PROJECT: Public Safety Dispatch Remodel

ADDENDUM # 1

DATE: 5/6/22

Project Name: Public Safety Dispatch Renovation  
Burford Commons  
Terre Haute, Indiana 47809

COUNTERTOP WITH MOTORIZED BASE.  
BASE BY ISU  
COUNTERTOP BY CONTRACTOR

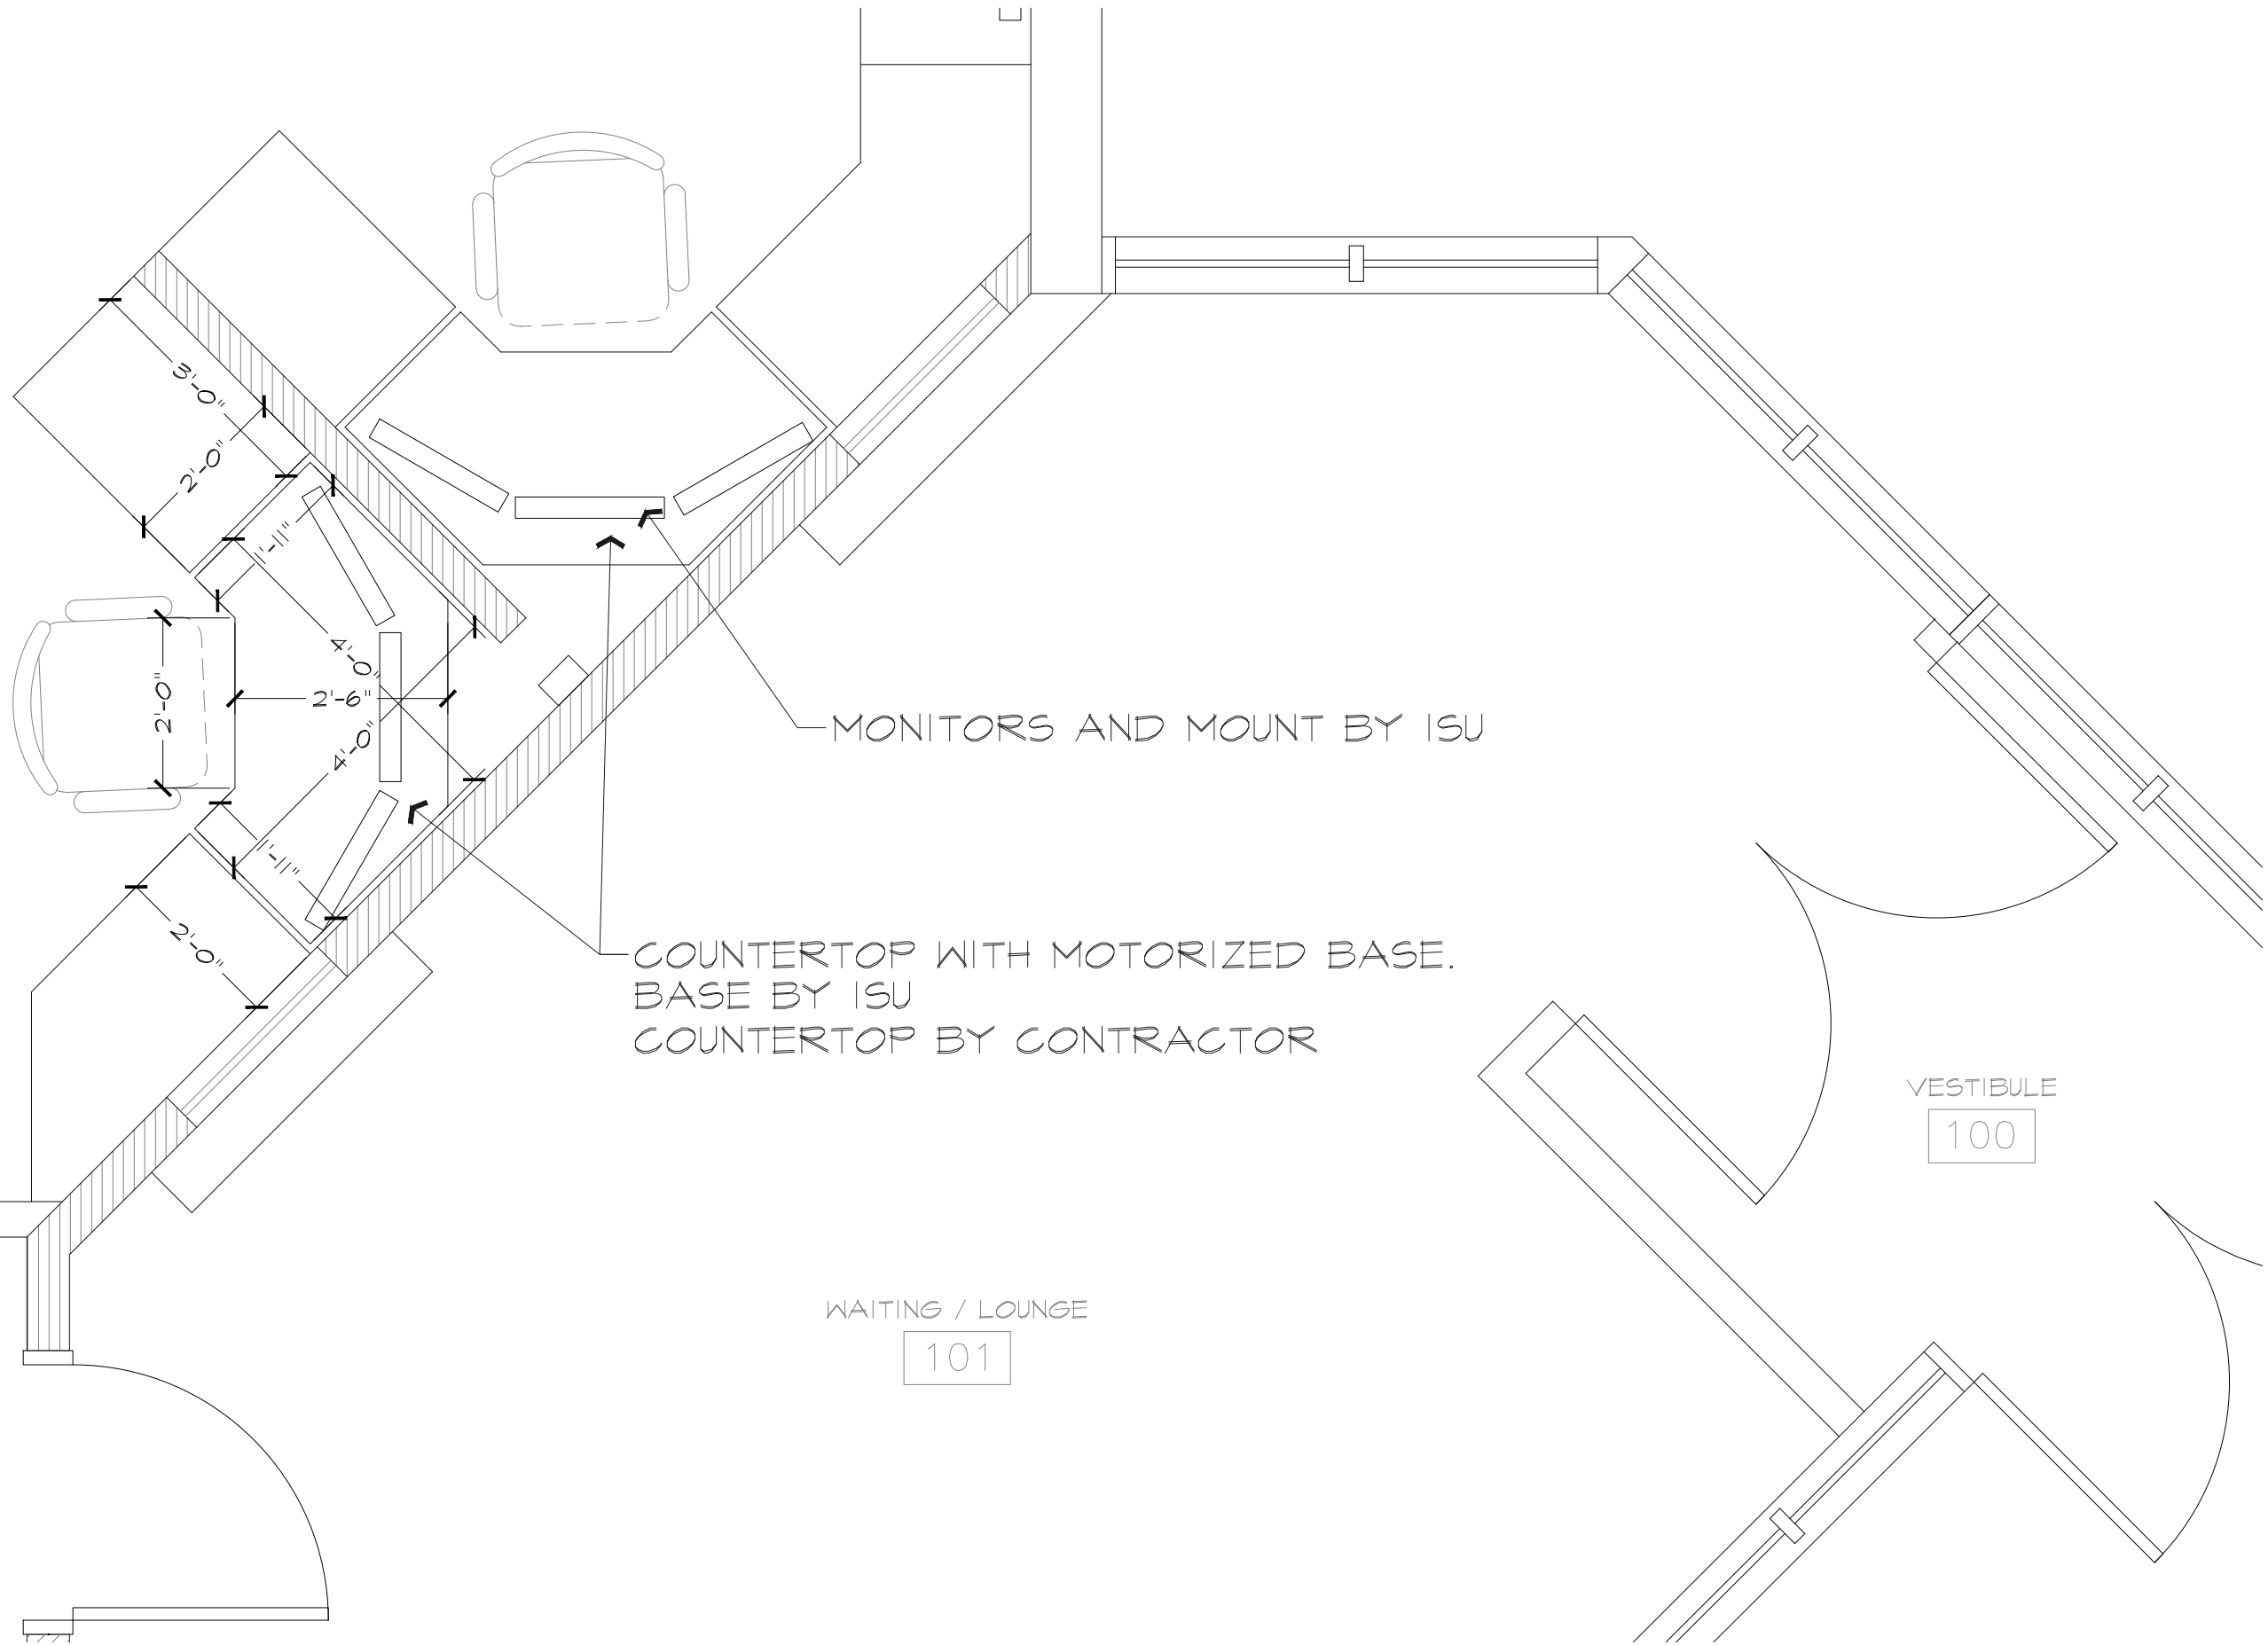
1. The two Dispatch front work countertops will be in three pieces with the corner section mounted on an owner provided motorized base. ISU will provide a detailed countertop drawing as part of this addendum. The other two pieces will still require mounting brackets anchored to the walls.
